TECHNICAL BULLETIN

Compressor Refrigerant Leaks – Sanden 709 R12 Compressors – Seal & Gasket Kits Available

82-51

MODEL 1991-92 MY Sedan Range DATE 9/98
1993 XJS Range

ILLUSTRATION 1

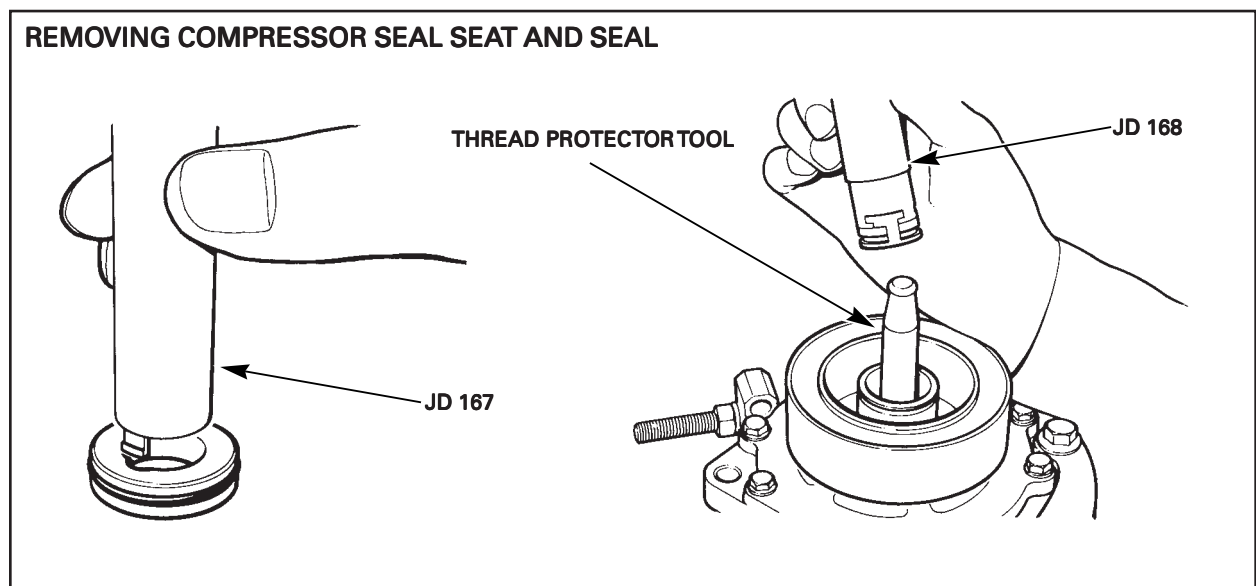
Sanden 709 A/C R12 compressors (part no. CCC-4929) used in Sedan Range and XJS vehicles are often replaced needlessly because of seal leakage. Gasket kits and seal kits are available to service these compressors using special tools JD-167 and JD-168 (Illustrations 1 and 2).

After determining the source of refrigerant leakage from the compressor, replace the shaft seal (repair operation number 82.10.11) and/or the compressor valve plate gaskets (repair operation number 82.10.26) as required.
